Business Park
Plot J2

DESIGN RESPONSE STATEMENT

2022-052-DOC_04 ISSUE NUMBER: P03

On 16th February, Rochdale Borough Council's Planning Committee considered a planning application submitted by Wilson Bowden Developments Ltd. The application (22/01200/FUL) was a full application for the 'Erection of two industrial/warehouses (Classes E(g) (iii), B2 and B8) with ancillary office space, new access, car parking, servicing, boundary treatments, hard and soft landscaping and other associated works.

Building Section B-B - Current Proposal

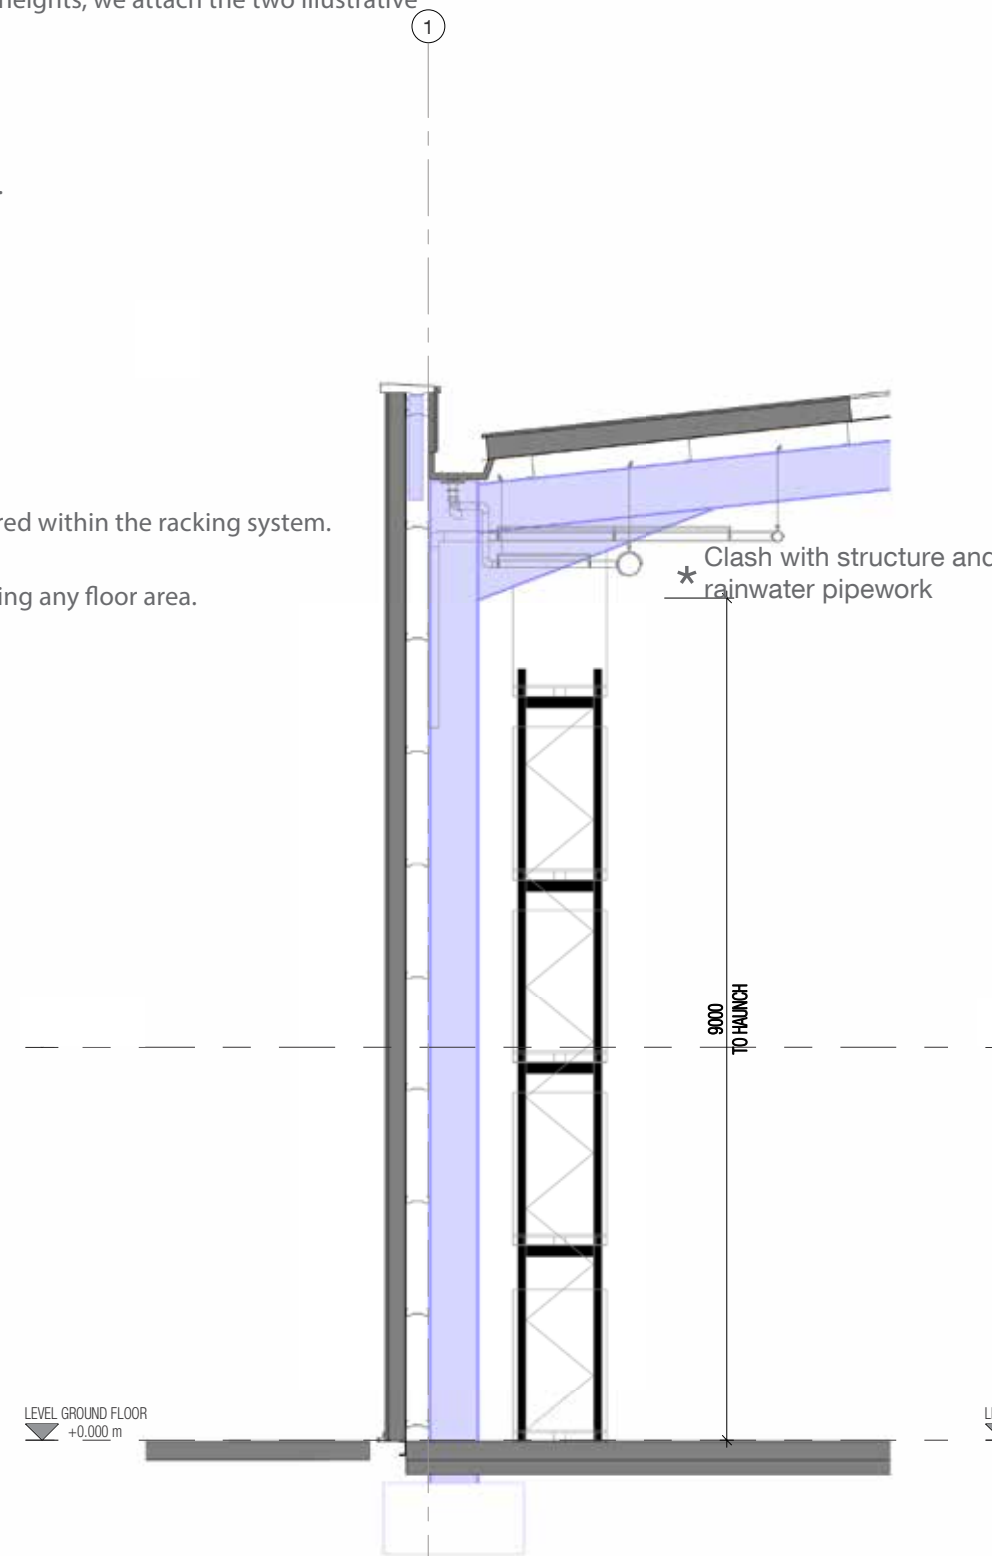
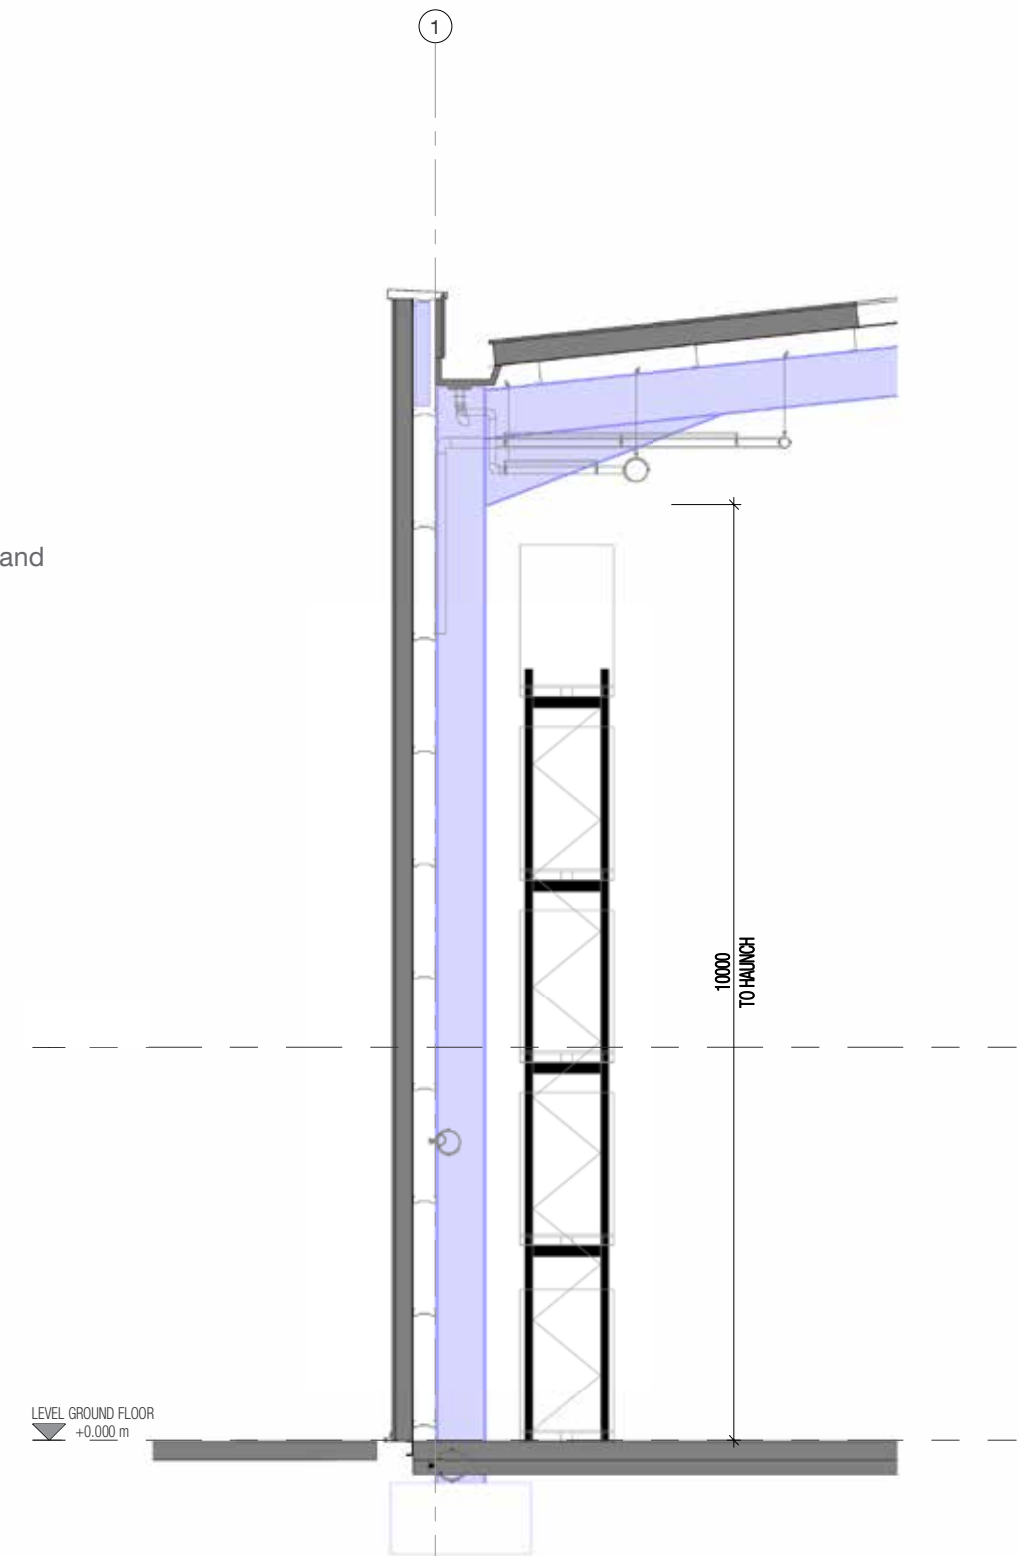
In order to articulate the additional volume generated by the modest increase in building heights, we attach the two illustrative sections representing Unit J2.

Illustrative Building Section A-A illustrates the Outline Approved 9m height to haunch.

Illustrative Building Section B-B illustrates the current proposal for a 10m height to haunch.

Working off an industry standard pallet height results in a vertical racking lift of:

- L0 to L1 - 0.000m to 2.100m
- L1 to L2 - 2.100m to 4.050m
- L2 to L3 - 4.050m to 6.000m
- L3 to L4 - 6.000m to 7.950m
- Overall height plus minimum clearance = 9.8m

Increasing the height to haunch from 9m to 10m therefore enables a fifth palette to be stored within the racking system.

This increases the volume of goods that can be stored in the space by 25% without increasing any floor area.

Section A-A

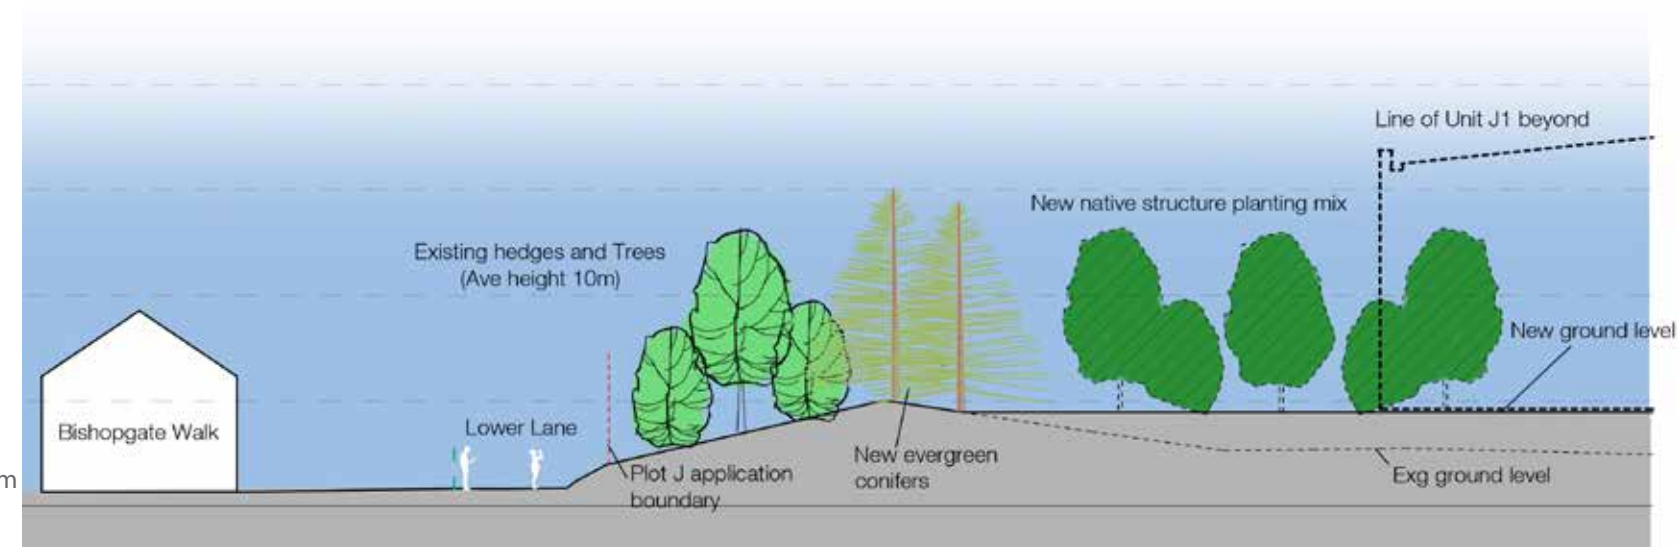
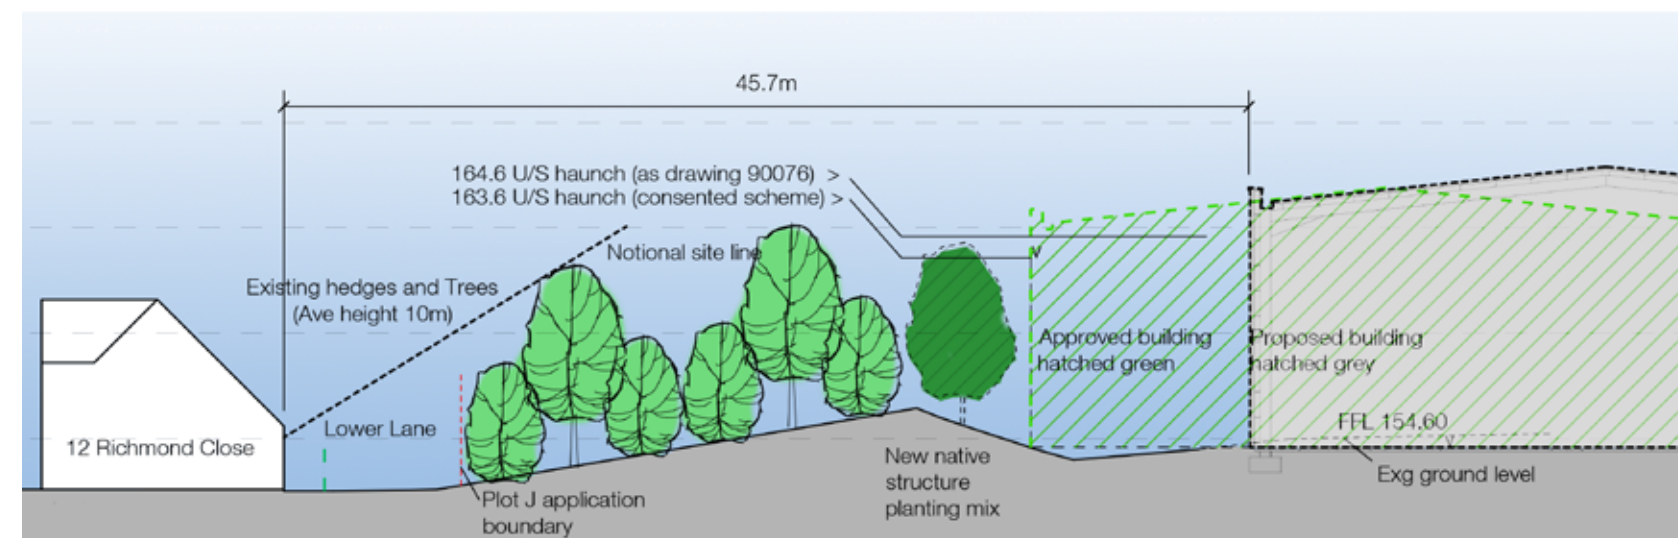
2.2 Height increase and visual impact

- The finished floor of the proposed building is compliant with the Outline Permission.
- The finished floor level cannot be reduced further due to the relative height of James Kearns Avenue and the maximum gradients permitted for safe HGV access into the site.

- The level of James Kearns Avenue adjacent to the Unit J2 HGV access is approx 157.00m.
- The finished floor level of Unit J2 is 154.60m.
- The 2.4m level difference between the building finished floor level and access road result in the HGV site access at 1:15 and cannot be steepened.

- To reduce the gradient the second option would be to move the building further away from the highway but this would move the building closer to the dwellings and was not implemented.

- With a specific focus on visual impact it should be noted the building will not be readily visible from the adjacent dwellings.
- Kingsway Business Park is screened from surrounding dwellings by carefully designemature structure landscaping and earth bunds implemented previously by Wilson Bowden Developments .

- In relation to Plot J2 the existing earth bund has a surveyed height to the top of the bund varying from 155m to 158m
- The existing structure landscaping has a surveyed height averaging 10m.

- This results in a height to the top of structure landscaping averaging from 165m to 168m.
- The height to the underside of haunch is 164.6m.
- The approximate height to the top of parapet is 167.2m (subject to confirmation following steelwork design).

- Noting the above, this clearly supports the information presented in Site Section A-A and B-B illustrating this proposed relationship and site lines.

Section C-C

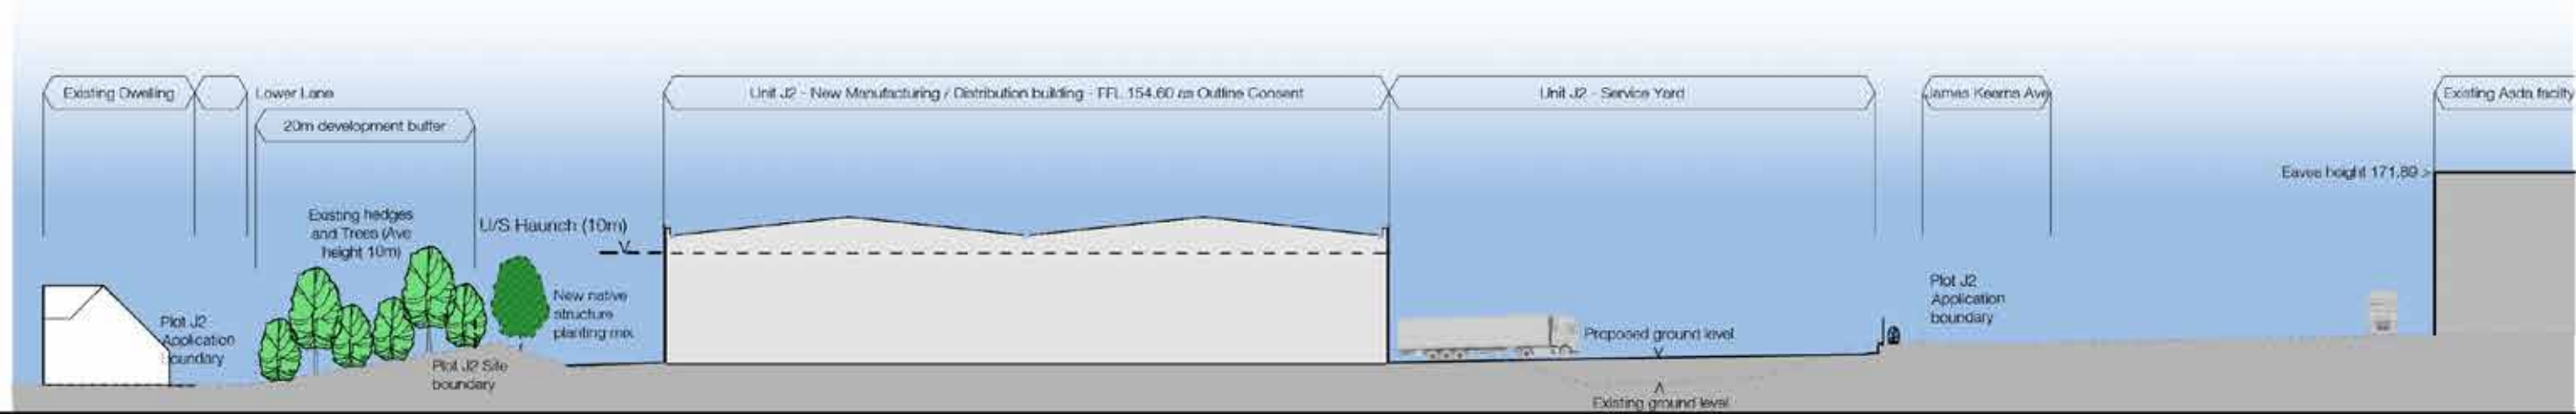
2.3 Unacceptable noise

In addition to scale the Plot J2 development is designed to place operation service yard spaces away from neighbouring residential dwellings.

The buildings will therefore assist in screening both Unit J1 and J2 but also offer some relief to the direct sight lines from Asda as evidenced on Site Section C-C below.

The BWB Noise Impact Assessment confirms the revised scheme offers a betterment to the control of noise from the site. It confirms noise is not a determining factor in granting planning permission for the development.

Outline / Current Proposal Comparison Plan

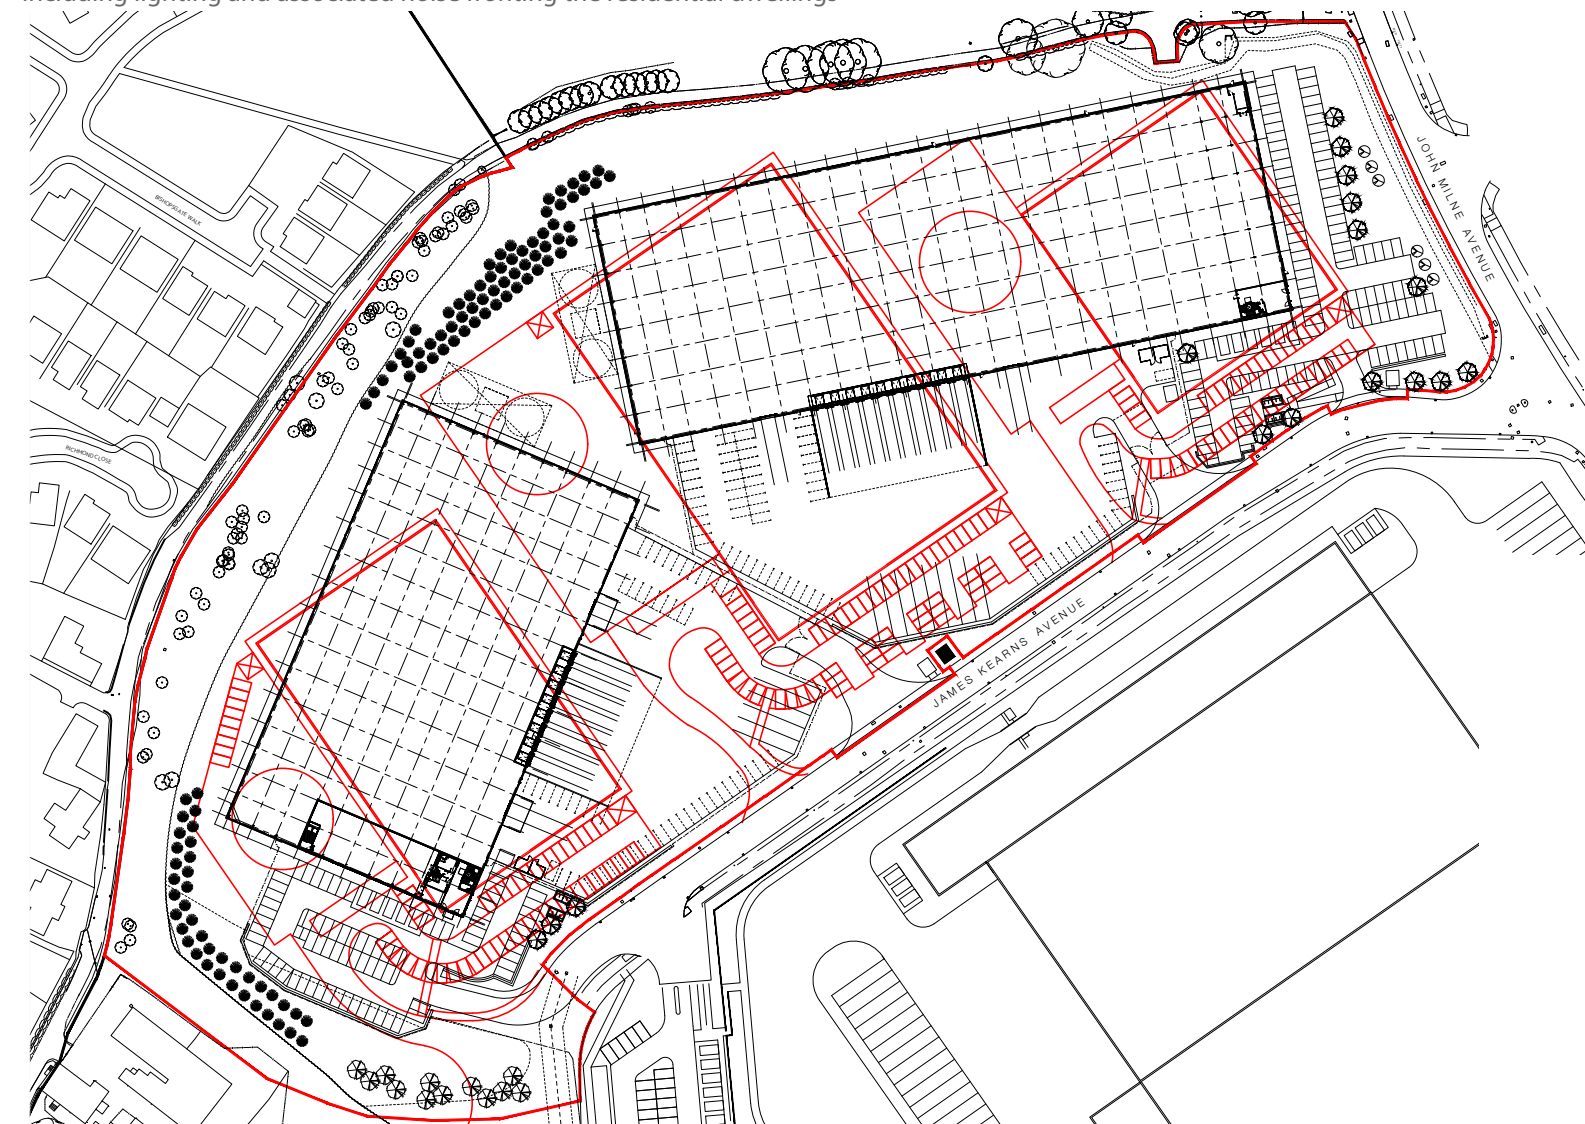
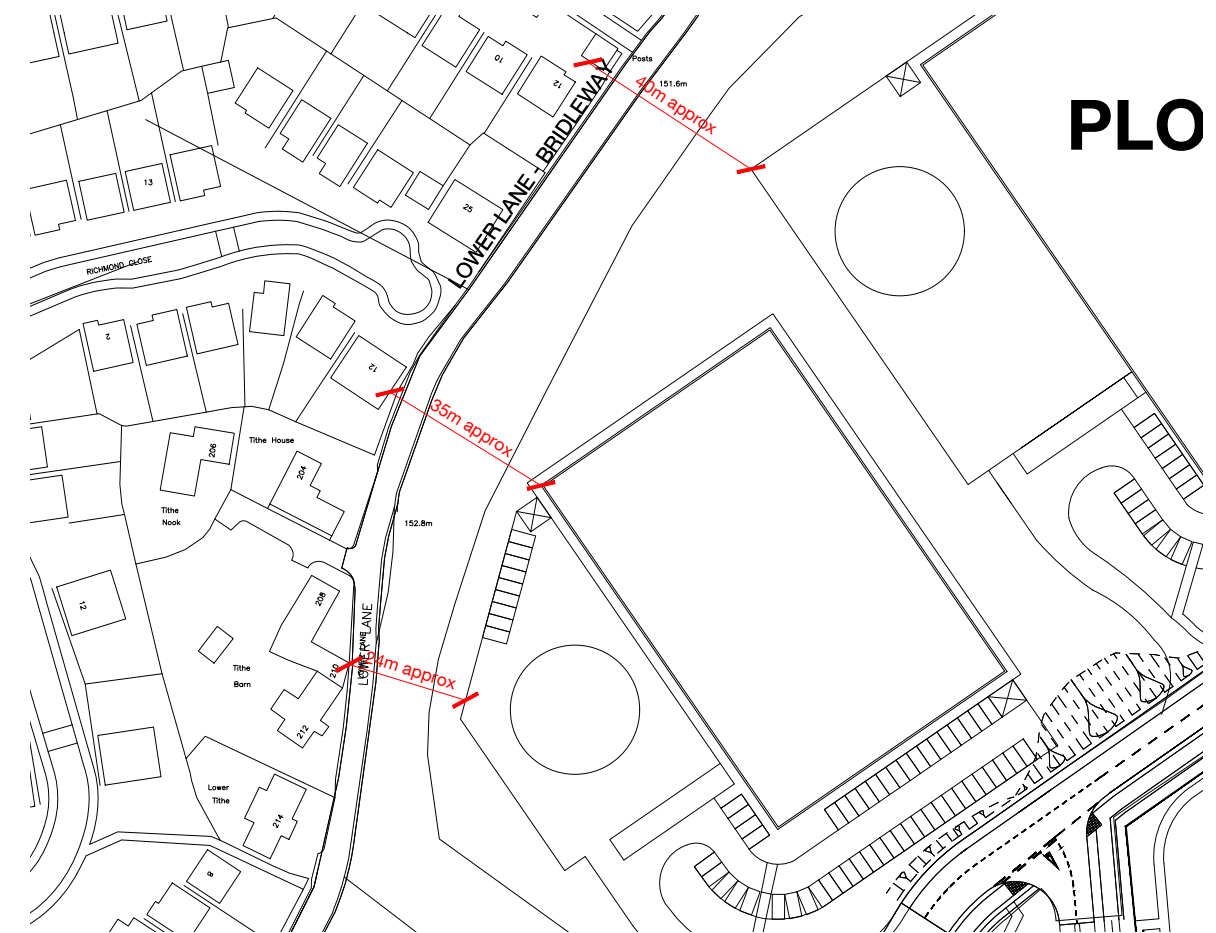
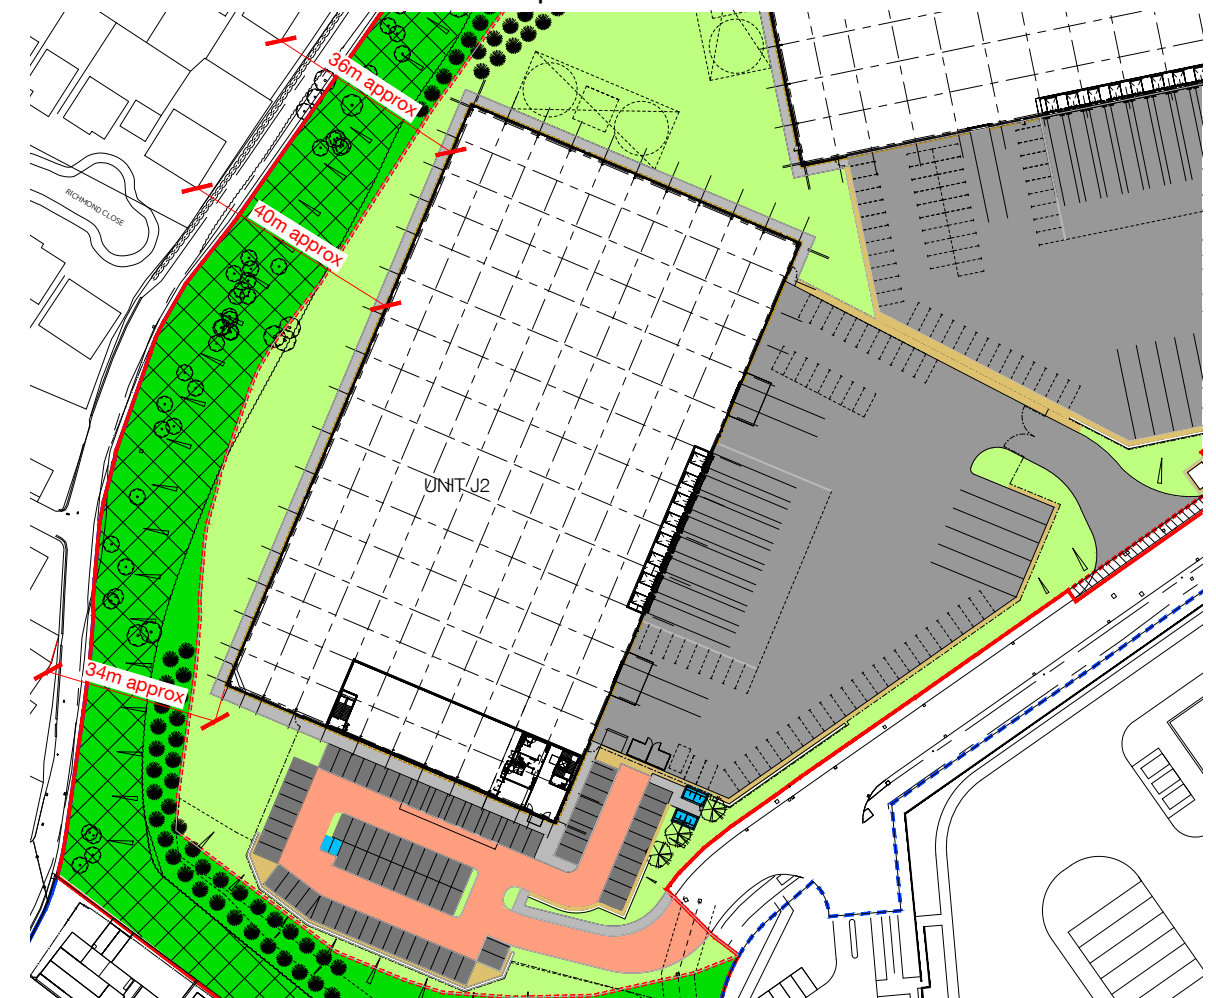
2.5 Over development

Whilst floor areas may have increased, the separation distance to the neighbouring dwellings did not significantly change. This is evidenced in the site plan extracts and overlay shown below:

- Building 34m from nearest dwelling (Tithe Barn)
- Building 40m to nearest dwelling on Richmond Close
- Building 36m to nearest dwelling Bishopgate Walk

- Operational yard within 24m of Tithe Barn
- Building 35m to nearest building on Richmond Close
- Operational yard within 40m of Bishopgate Walk

Buildings and/or operational yards are generally further away from nearest dwellings than the 2014 Outline Permission where operational yards including lighting and associated noise fronting the residential dwellings
